DEVELOPMENT REVIEW COMMITTEE (DRC) COMMENT REPORT

PROJECT NAME: Bahia Mar

CASE NUMBER: UDP-PDD22004

REQUEST: Site Plan Level IV Review: Rezoning Request from South Beach Marina and Hotel Area District (SBMHA) to Planned Development District (PDD) for 410 Multifamily Residential Units, 88,000 Square-Feet of Commercial Use, and 256-Room Hotel in Central Beach Regional Activity Center

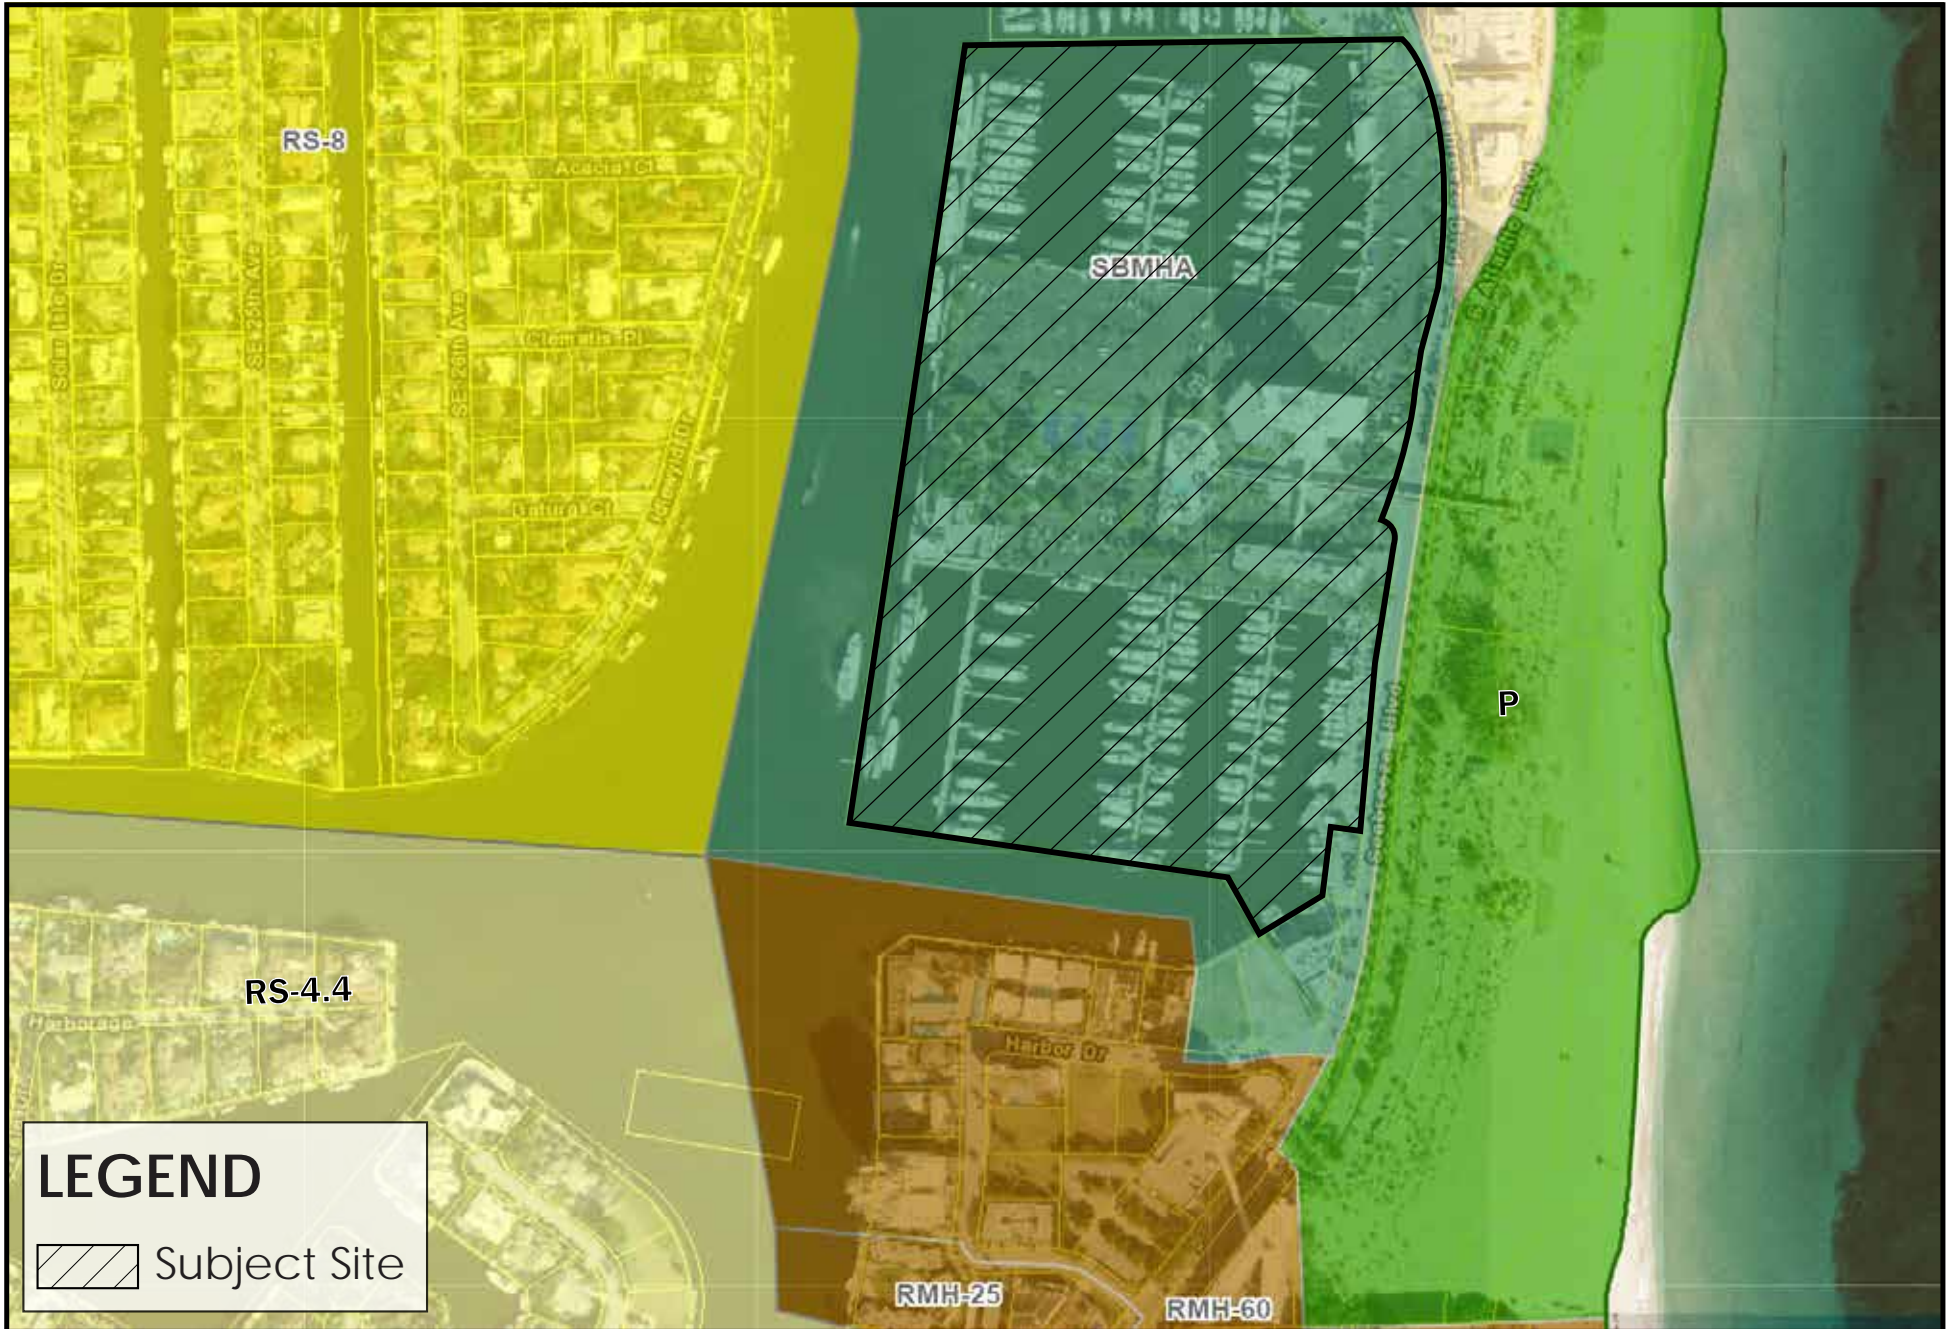
- The northernmost parking lot area is depicted with hatched lines and is noted as valet and flex space. Clarify the intent of this parking area. Consider using this surface parking area in a positive way that contributes to the public realm such as removable planters, removable benches, additional landscape material, etc. Revise the design accordingly. See images below.
